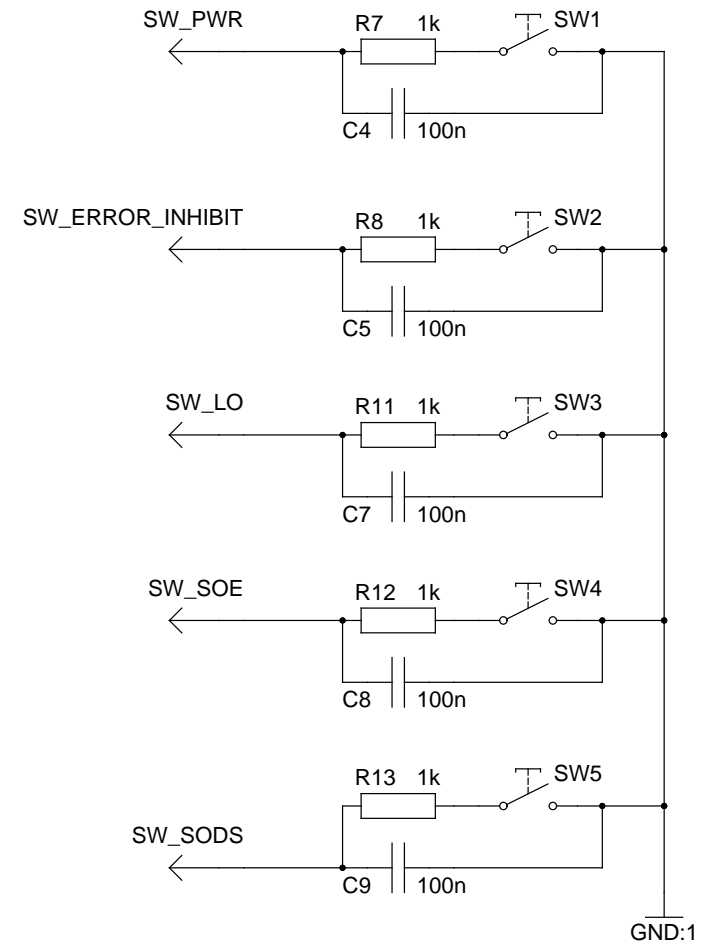
option:
 use separeate 5V→2.5V LDO
 for ADC_REF and as POTI supply.
 reduces part count and noise because
 the 3V3 rail has changing loads, for
 example flashing LEDs.
